Planning & Zoning Board

Thursday, April 3, 2025

**MINUTES REGULAR MEETING
REYNOLDSBURG PLANNING & ZONING BOARD
March 20, 2025**

On behalf of the City of Reynoldsburg, EMH&T conducted a preliminary engineering review of the Major Site plan for the 6493 East Main Street Project. The Major Site Plan for this project has been submitted and is currently under review. The project intends to utilize the existing building for a fast food restaurant with a proposed drive-thru. The proposed drive-thru is a part of the Conditional Use Permit Application request submitted to the City. The following summarizes our findings and recommendations with respect to this development.

SITE PLAN

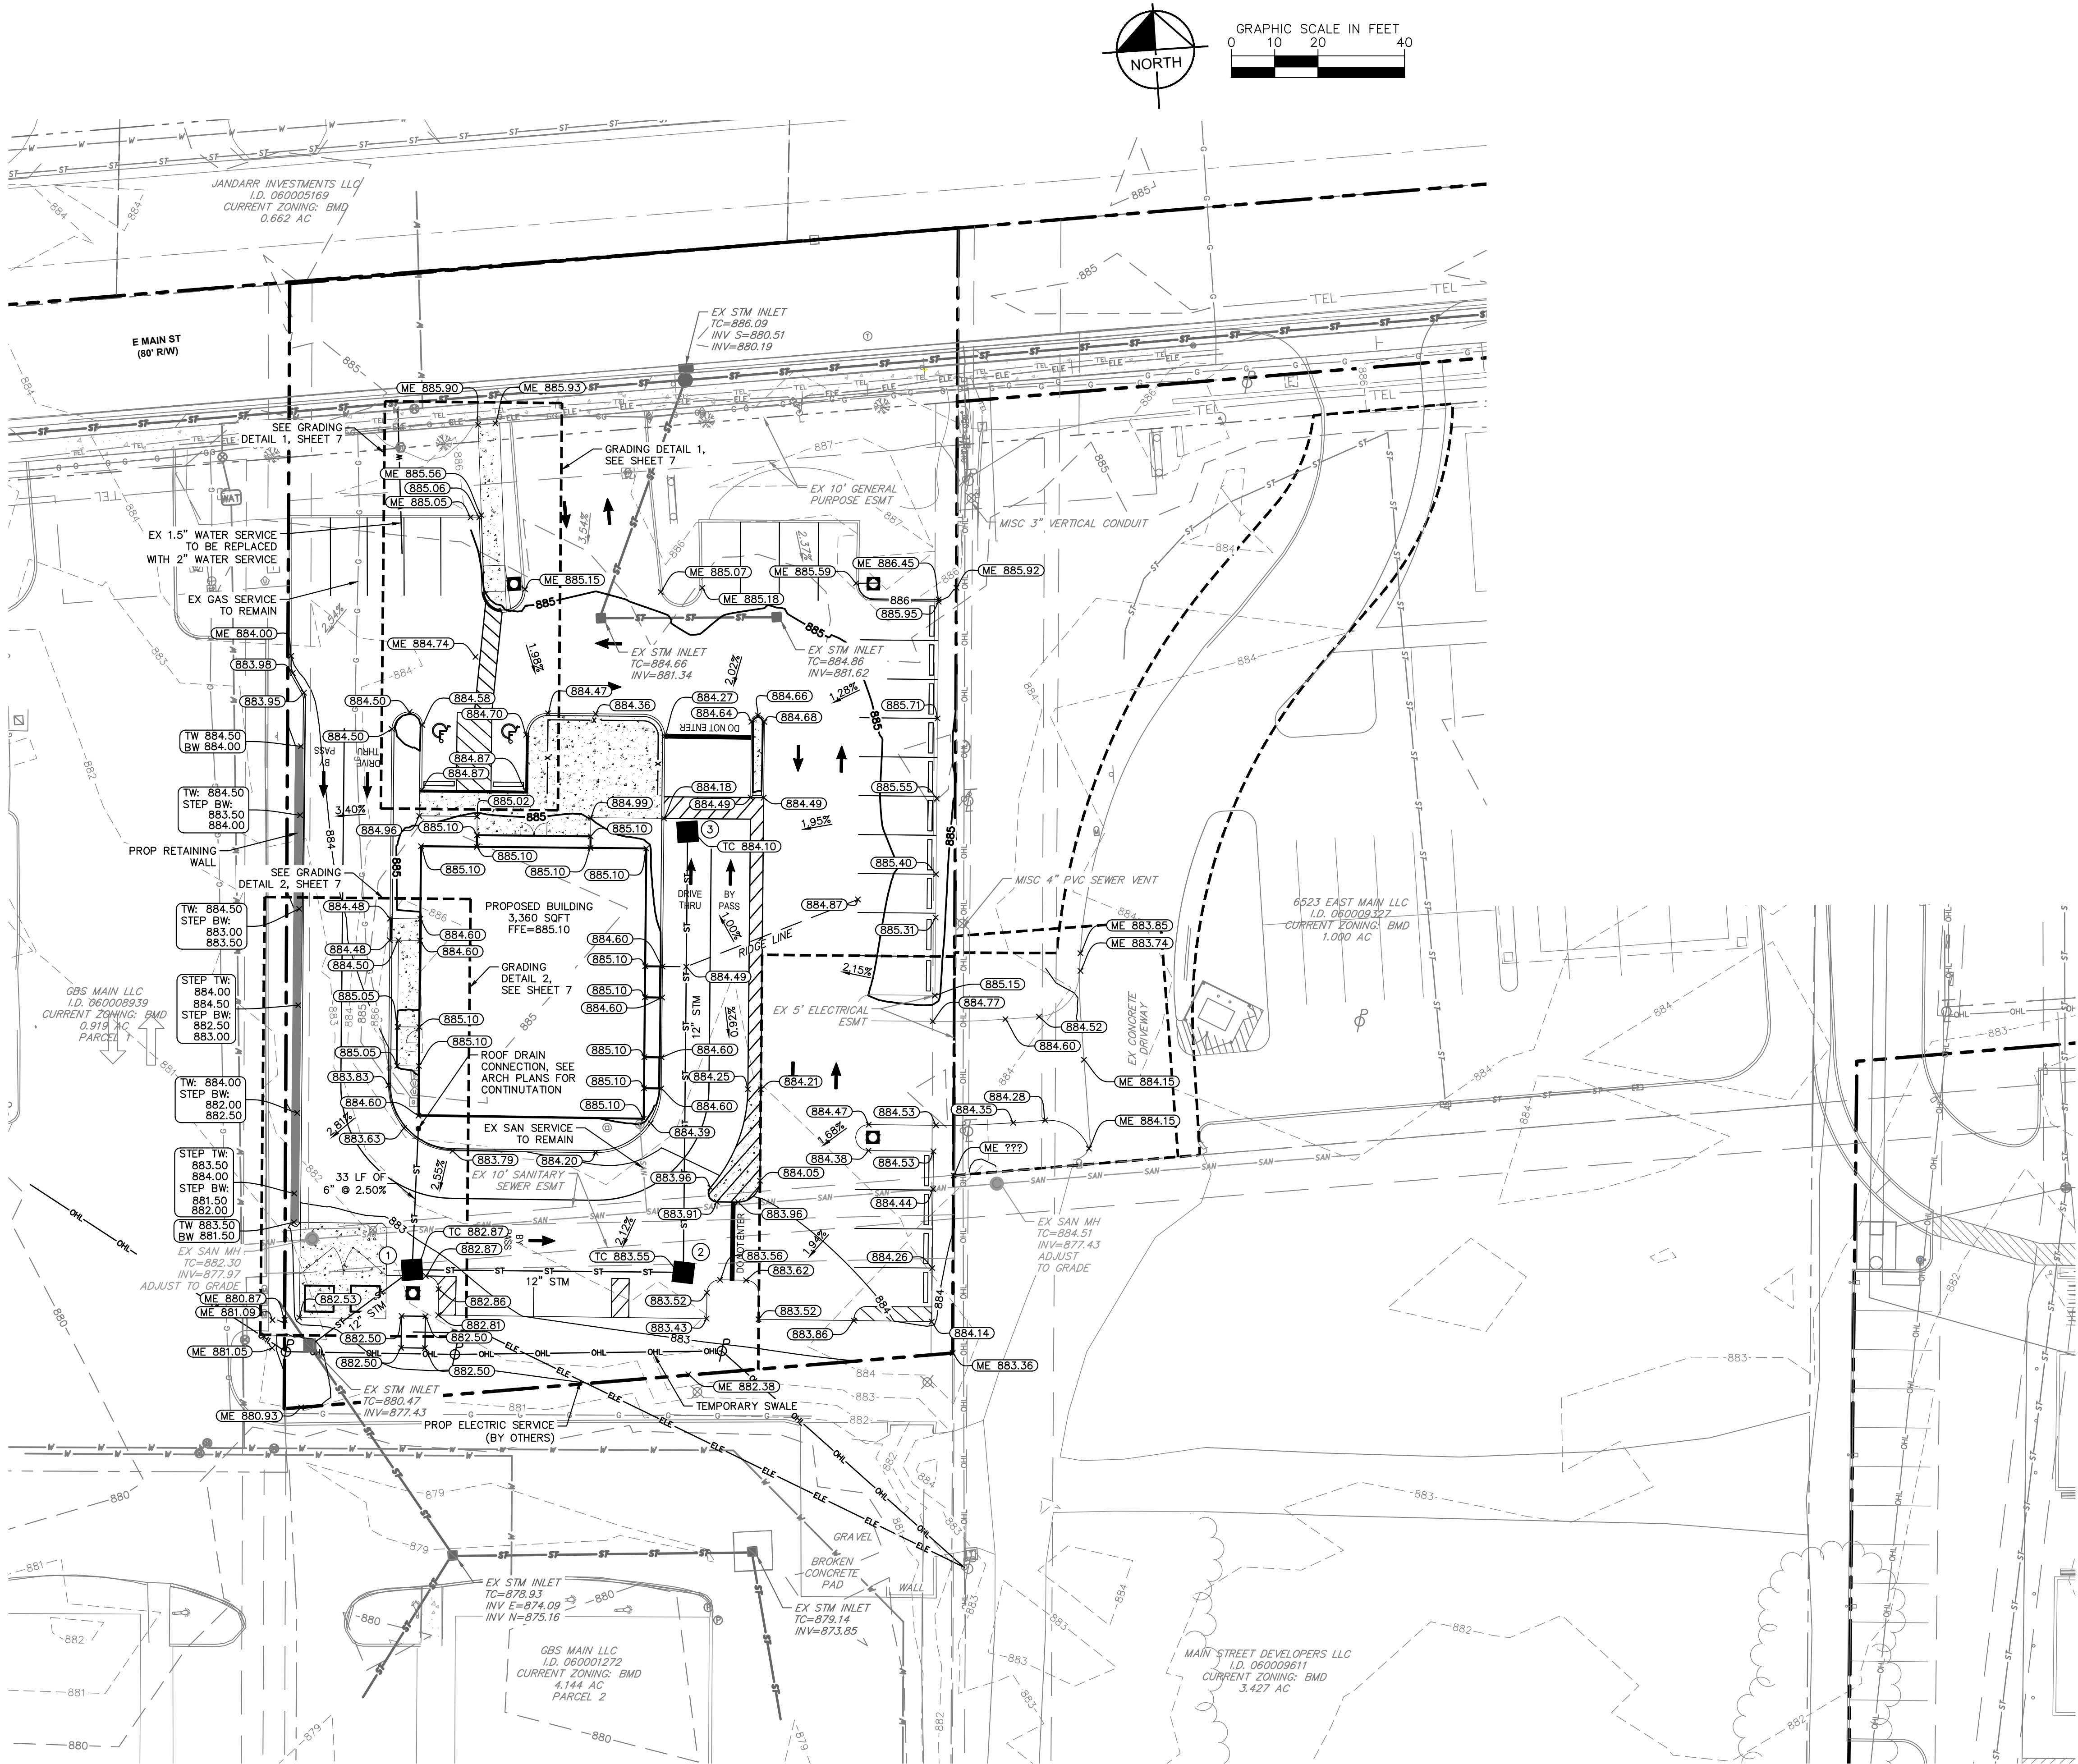
3. There is a proposed drive-thru lane (11' width) which begins on the west side of the building and travels southward to circle the three sides of the building. Additionally, there is a proposed by-pass lane (9' width) to the right of the drive-thru lane. These tandem one-way lanes exit to the north parking lot onto the two-way traffic area (24' width) and are acceptable. However, the drive-thru car stacking count needs to be included on the site plan.

4. A fire truck maneuverability plan was not submitted with the PGU. This should be included in future submissions.
5. Parking spaces are 9' x 18' and are acceptable. Although there are five dedicated parking spaces on the property which are for WPCU use (see 1.a.), there is still enough parking per the plan to meet the requirement of a minimum 17 spaces. The plan shows at least 23 parking spaces (2 ADA included, WPCU NOT included), but there is a discrepancy in the count between the plan sheet and the Parking

Count data table (20 versus 27). Additionally, there are three proposed spots on the south end of the project that fit the parking space dimensions, but they are not called out as parking spots nor are there any wheel blocs or curbs. This area needs to be called out for the intended purpose. Ultimately, the parking count will need to be revised on the plan sheet, but it will not impact the requirement since the final number of spaces will be above 17.

6. The sidewalk entrance from E. Main Street's public right-of-way is shown to be 5-feet wide, which is acceptable by ADA standards and meets the City's typical width of 5-feet.
7. A bike rack has been proposed on the north side of the building. However, a detail of the bike rack and the location needs to be provided given it is near the entrance of the building and is in front of one of the ADA parking spaces.

8. The existing 1.5-inch water service line connects to the 8-inch watermain on E. Main Street. The existing water service will be replaced by a 2-inch line. The alignment was not included on the proposed plan sheet and a comment was made to include the proposed 2-inch line alignment from the 8-inch tie-in to the building.
9. The existing sanitary sewer lateral will remain connected to the 8-inch sanitary sewer located on the south side of the building. The existing sanitary sewer is within an existing 10-foot easement. Pipe diameters (and record numbers, where applicable) of existing and proposed utility lines for the project need to be included on the plans.
10. The existing gas service line will remain in place.
